PRELIMINARY CONSULTATION WITH EA
+ SOIL TEST RESULTS

RE: Proposed Slurry Lagoon - Higher Greenhead Farm

Contract Title: Higher Greenhead Farm

Hole 1

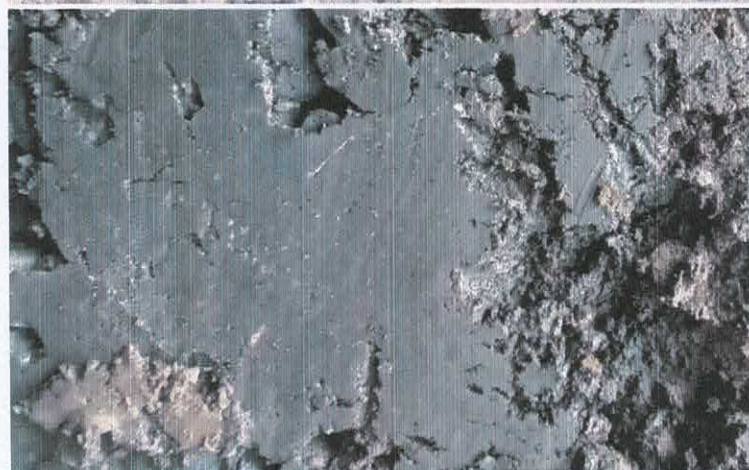
"we are content to accept this result. Although the material is actually only 25% clay, the permeability test (presumably undertaken in accordance with the relevant British &/or International Standard) implies that it is suitable for use as a lining material. Although the photos show it does look quite sandy (the analysis indicates 38% sand or gravel), I agree it does look to be free from stones. In addition, it looks quite stiff (dense). This is consistent with the clay being of glacial origin"

So no need to import any lining material!
